ARKANSAS NUCLEAR ONE - UNIT NO. 1

AMENDMENT TO FACILITY OPERATING LICENSE

Amendment No. 68
License No. DPR-51

SAFETY EVALUATION BY THE OFFICE OF NUCLEAR REACTOR REGULATION

ROD POSITION LIMITS FOR FOUR-PUMP OPERATION FROM 400 ± 10
TO 455 ± 10 EFPU - ANG-1, CYCLE 5 (TECH SPEC FIGURE 3.5.2-10)

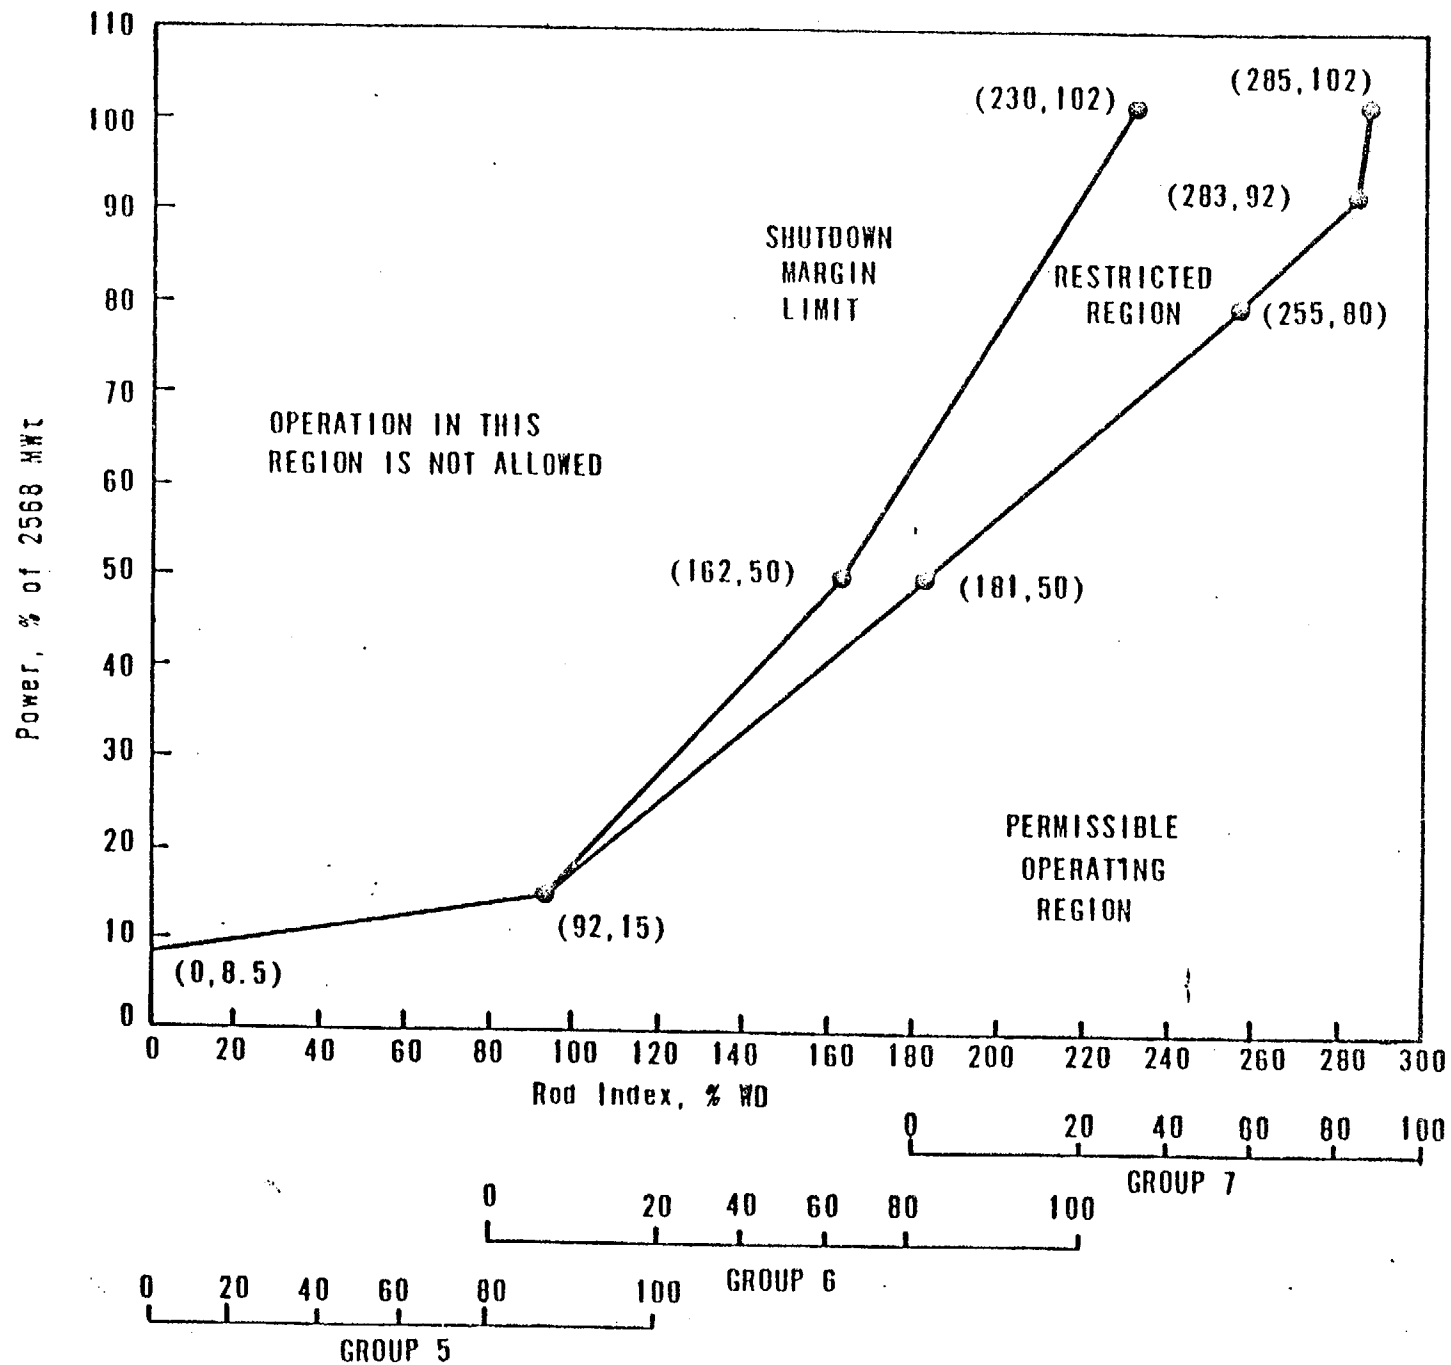
1. Regulating Rod Insertion Limits from 400 to 455 EFPD for four, three, and two-pump operation.
2. Axial Power Shaping Rod Insertion Limits from 400 to 455 EFPD.
3. Axial Power Imbalance Envelope from 400 to 455 EFPD.

APSR POSITION LIMITS FOR OPERATION FROM 400 ± 10
TO 455 ± 10 EFPD - ANO-1, CYCLE 5
(TECH SPEC FIGURE 3.5.2-4D)

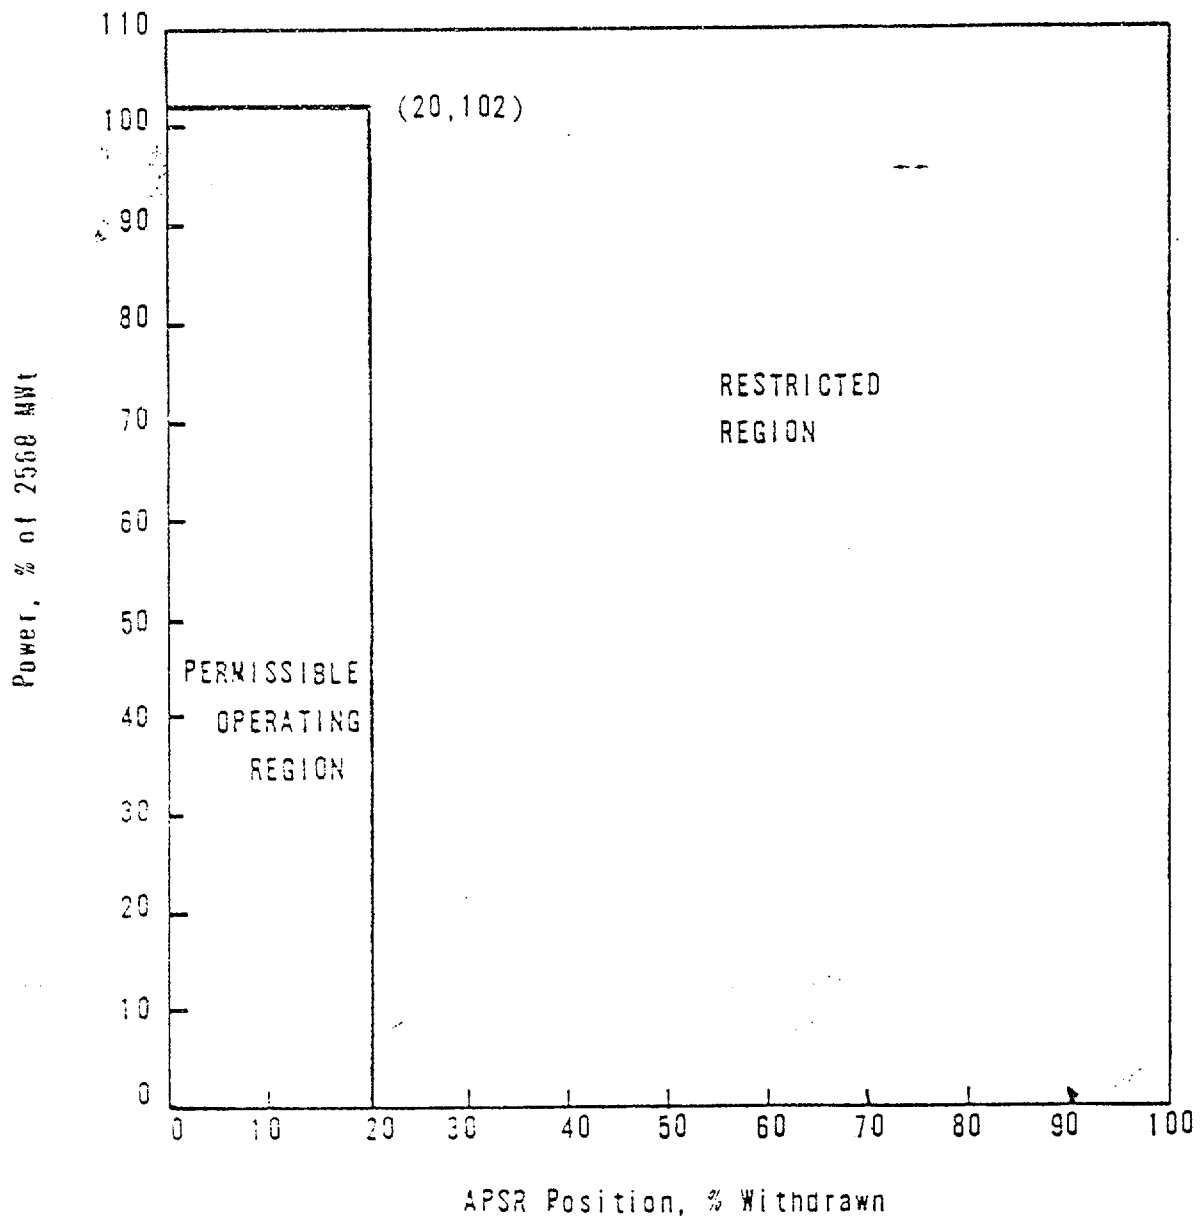
Since minor warpage could conceivably cause difficulties in fully inserting the APSRs at EOC in preparation for refueling, the proposed operation during the last 55 EFPD with the APSRs fully inserted is a precautionary measure. All of the APSRs will be replaced at the EOC 5. There would be no loss of shutdown margin since the APSRs are not relied upon and do not automatically insert during a reactor trip. Based on this and the fact that the same techniques and models were used to derive the TSs as were used to derive those for the previous cycles, we conclude that the modified TSs required to operate to 455 EFPD with the full insertion of the APSRs during the last 55 EFPD are acceptable.
